Project:	EPS
Part Number:	80000258
Assembly Name:	LH7A404-11
Schematics	ECR

Title	LH7A404-11 Card Engine	Rev	201
Size	Custom	Number	80000258
Design Create Date	Friday, October 18, 2002	Project	LH7A404-11
		Sheet	2 Of 12

## 12 - ECO LIST

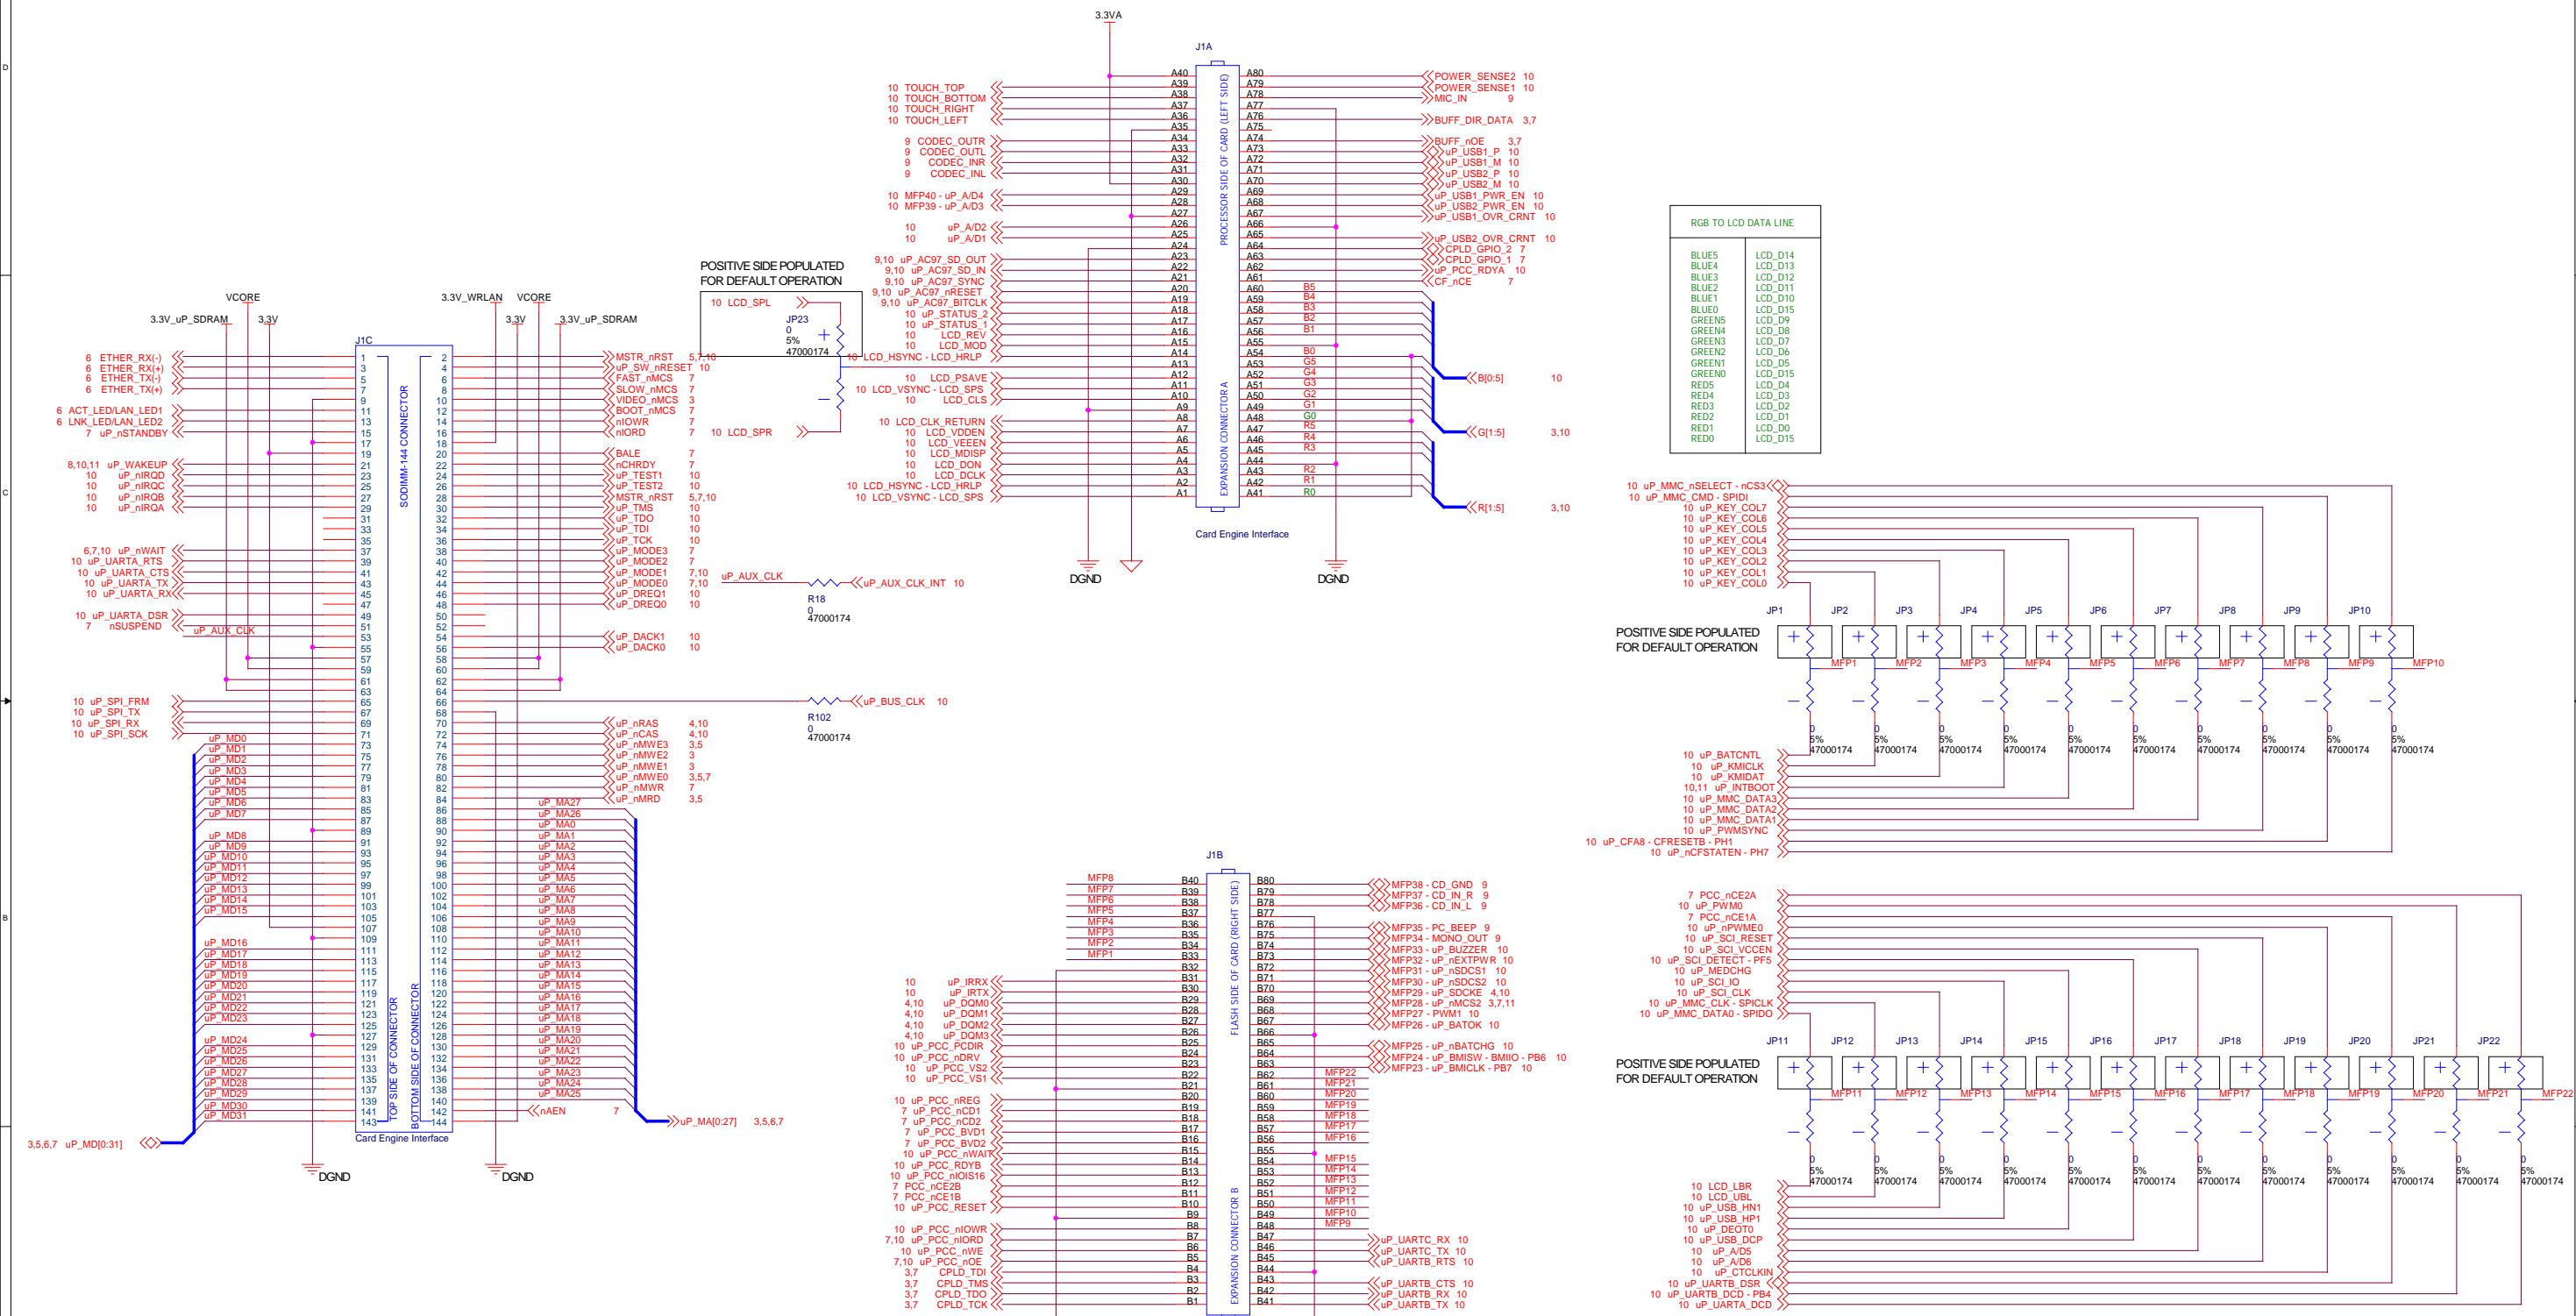
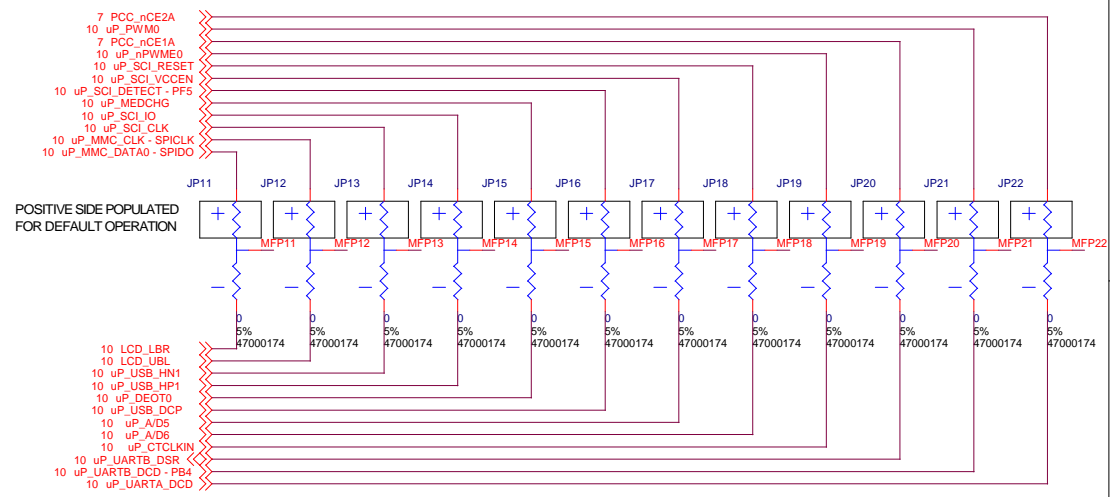
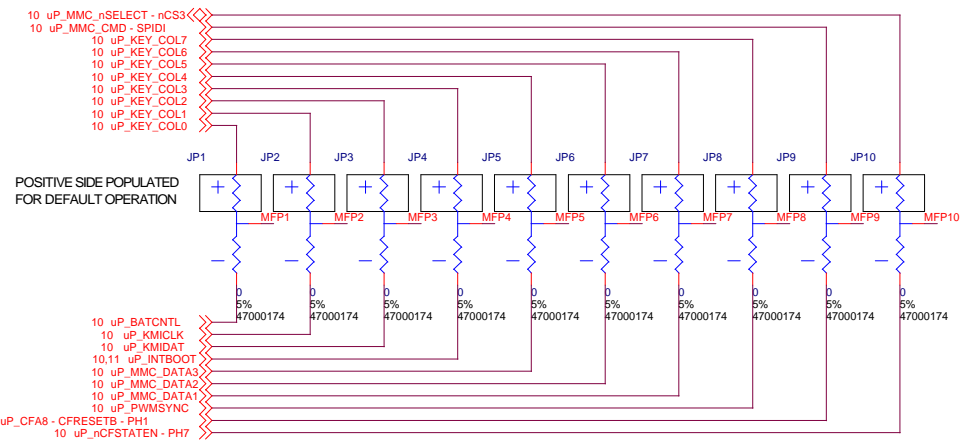
5) REMOVED NET MFP27 - uP\_nSDCS0 AND CHANGED TO MFP27 - PWM1

6) SWAPPED POSITION OF JUMPER CONFIGURABLE FEATURES KMCLK, KMDATA, INTBOOT, AND USBH1, USBHP1, USB\_DCP

- 1) REMOVED NET BUFF\_DIR\_ADDRESS FROM EXPANSION CONNECTOR A
- 2) CHANGED DEFAULT POPULATION OF THE JUMPER BLOCK
- 3) REMOVED NET uP\_PER AND REPLACED IT WITH uP\_UARTB\_RTS
- 4) SWAPPED NETS uP\_PCC\_RDYA AND uP\_PCC\_RDYB ON THE TWO EXPANSION CONNECTORS

- 1) SWAPPED uP\_PCC\_nCE1/2A AND uP\_PCC\_nCE1/2B
- 2) RENAMED MFP29 TO MFP29 - uP\_SDCKE
- 3) SWAPPED NETS CONNECTED TO EACH END OF JP11 - JP22 SO THAT + DESIGNATIONS WILL PROVIDE FOR EXACT PINOUT AS A400 CARD ENGINE
- 4) SWAPPED MFP37, MFP36 - CD\_IN\_R and CD\_IN\_L SIGNALS
- 5) SWAPPED MFP33, MFP32 - uP\_NEXT\_PWR AND uP\_BUZZER

- 1) CHANGED uP\_IRQ0 TO uP\_WAKEUP ON J1C
- 2) SWAPPED LCD\_REV AND LCD\_PSAVE SIGNALS
- 3) RENAMED TOUCHNETS
- 4) RENAMED uP\_USB\_DN, uP\_USB\_DP TO uP\_USB\_HN1, uP\_USB\_HP1 TO COINCIDE WITH USB ARCHITECTURE CHANGE FOR SDK BOARD
- 5) CHANGED uP\_PCC\_nCE2 TO uP\_PCC\_nCE2A, uP\_PCC\_nCE1 TO uP\_PCC\_nCE1A
- 6) REMOVED PWM SIGNALS AND REPLACED THEM WITH uP\_PCC\_nCE1B AND uP\_PCC\_nCE2B FOR DUAL PC CARD SUPPORT
- 7) MOVED uP\_PWM0, uP\_INTBOOT TO MFPS
- 8) REMOVED C37, C79

# 03 - BUFFERS

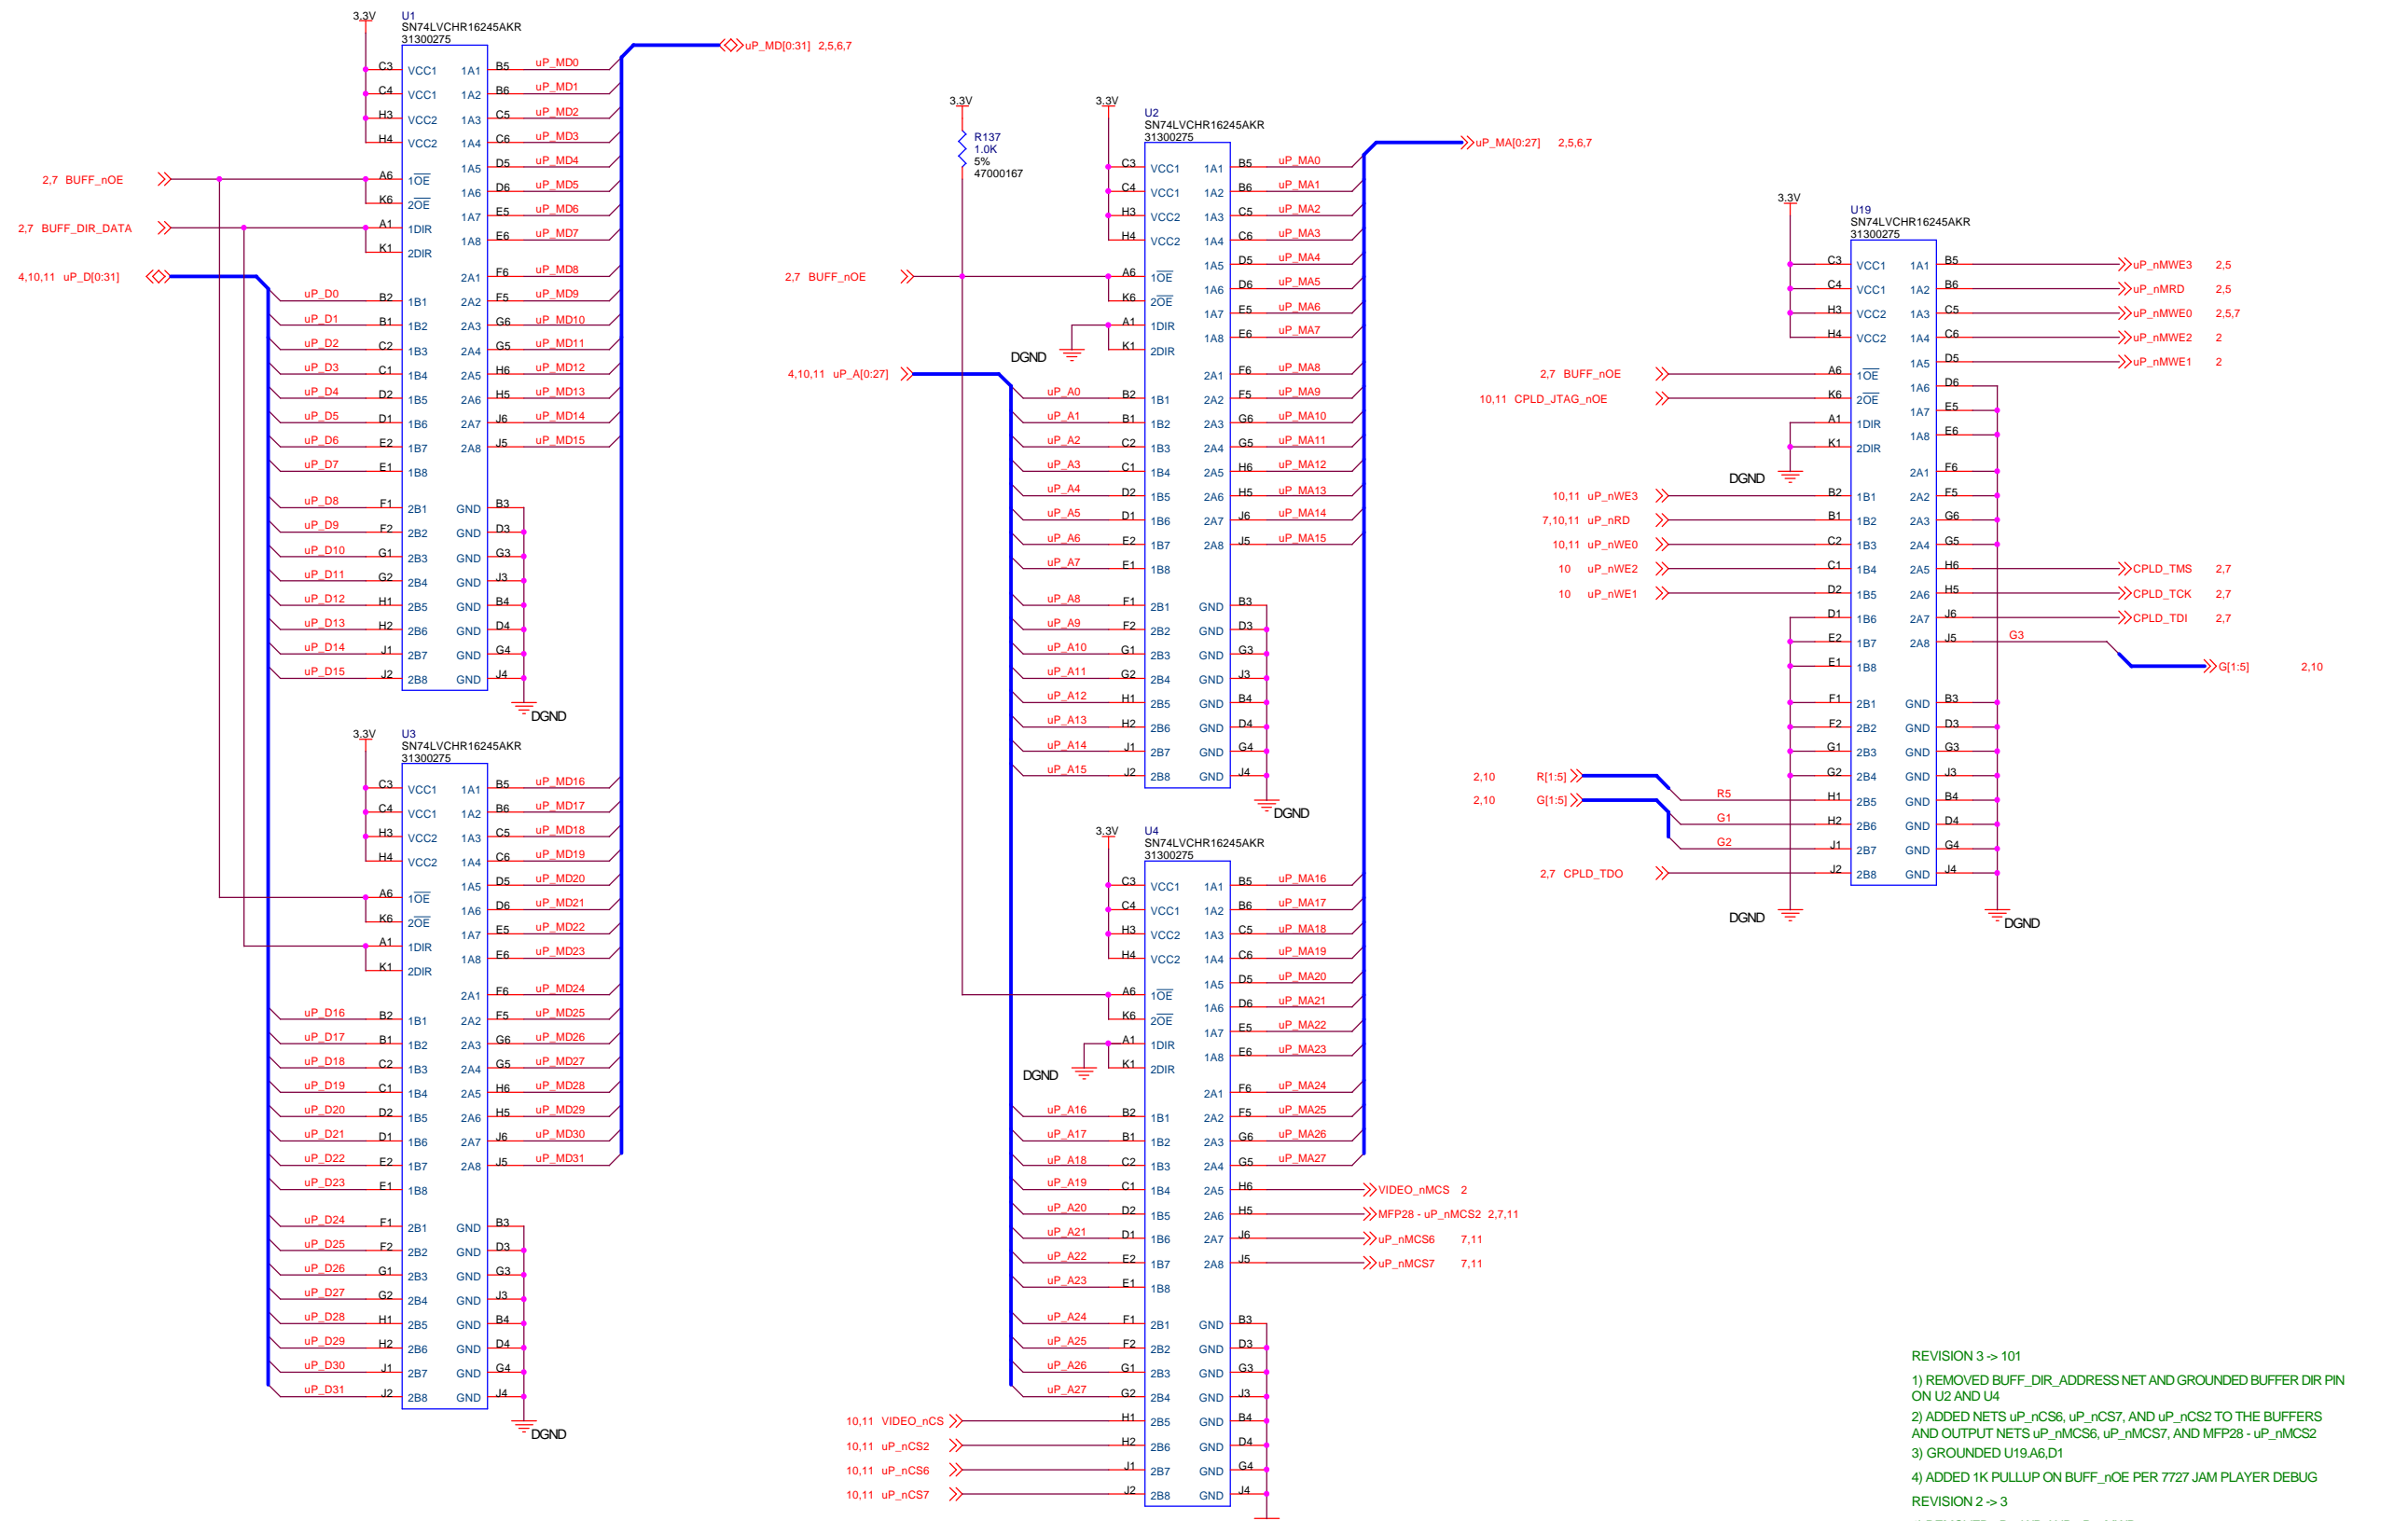
- REVISION 3 -> 101
- 1) REMOVED BUFF\_DIR\_ADDRESS NET AND GROUNDED BUFFER DIR PIN ON U2 AND U4
  - 2) ADDED NETS uP\_nCS6, uP\_nCS7, AND uP\_nCS2 TO THE BUFFERS AND OUTPUT NETS uP\_nMCS6, uP\_nMCS7, AND MFP28 - uP\_nMCS2
  - 3) GROUNDED U19.A6,D1
  - 4) ADDED 1K PULLUP ON BUFF\_nOE PER 7727 JAM PLAYER DEBUG
- REVISION 2 -> 3
- 1) REMOVED uP\_nWR AND uP\_nMWR
- REVISION 1 -> 2
- 1) REMOVED FAST\_nCS, SLOW\_nMCS, FAST\_nCS AND SLOW\_nMCS FROM U4

04 - SDRAM

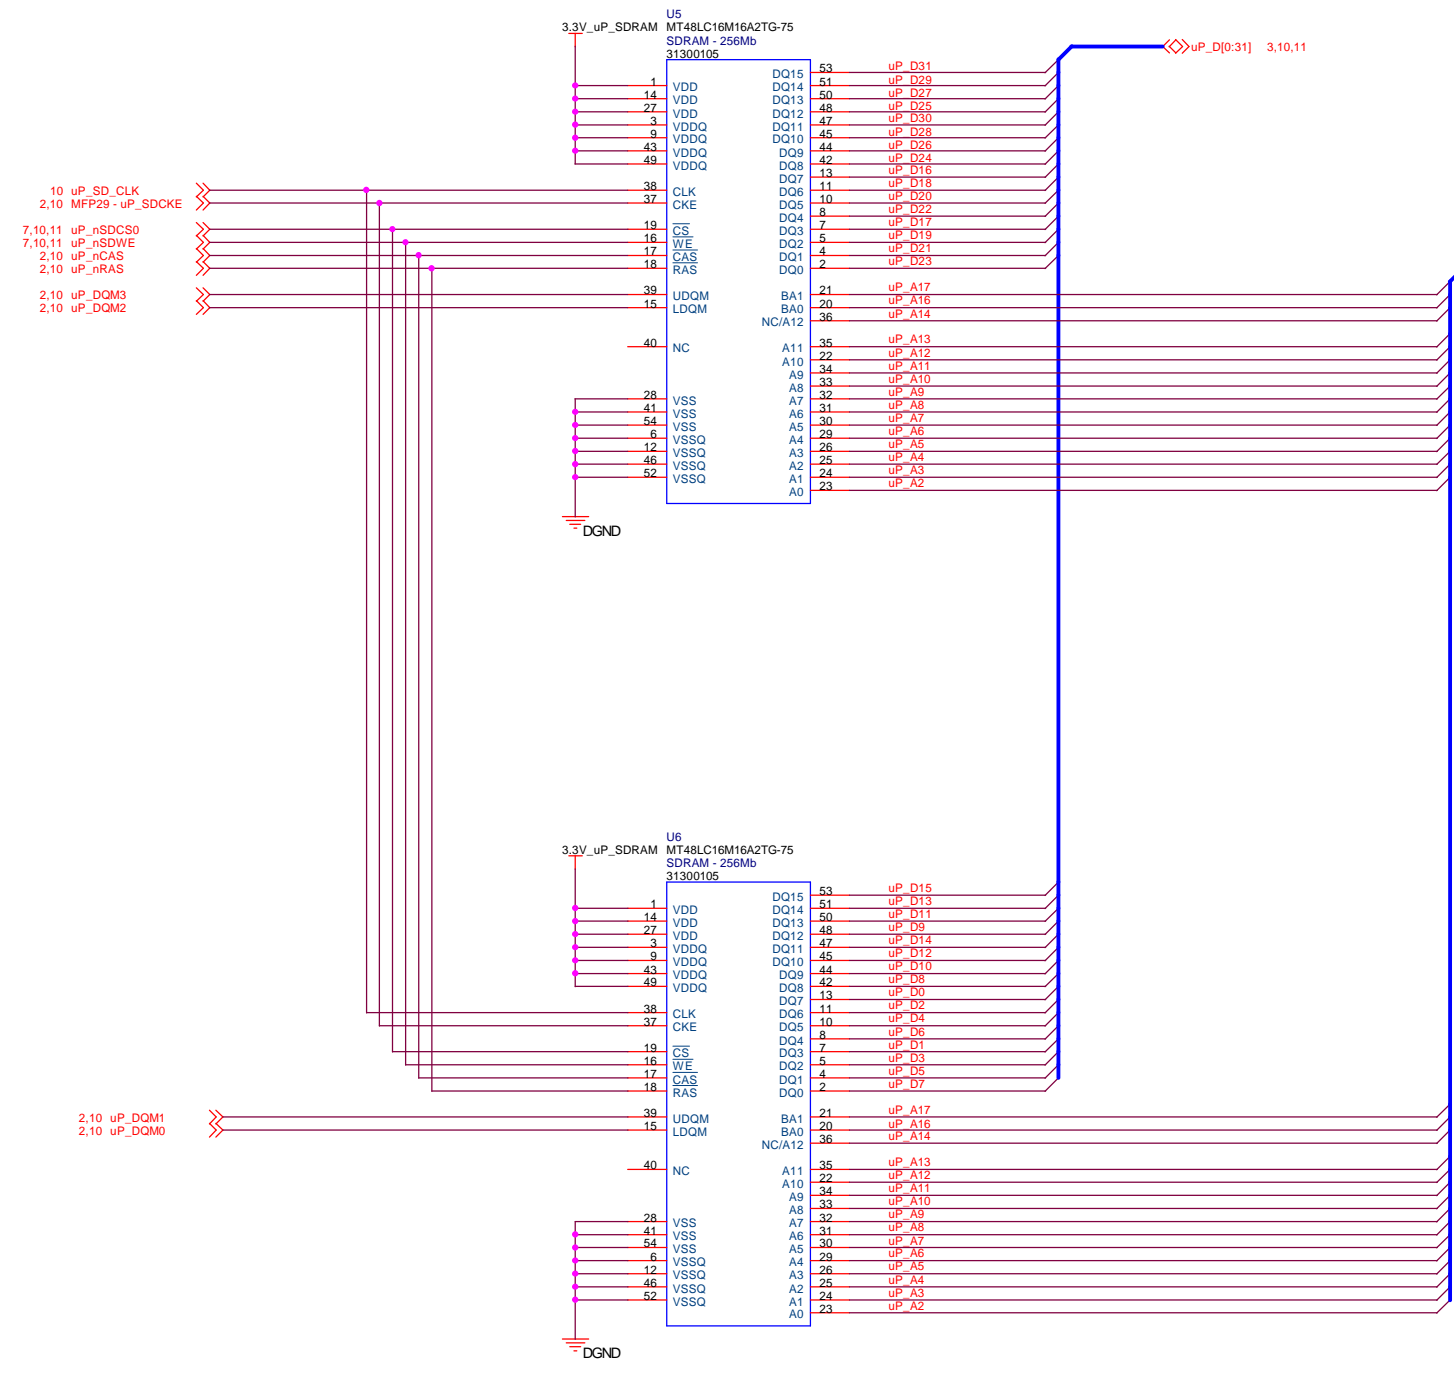
- REVISION 3 -> 101  
 1) CHANGED STANDARD SDRAM POPULATION TO 64MB  
 REVISION 2 -> 3  
 1) RENAMED uP\_SDCKE TO MFP29-uP\_SDCKE
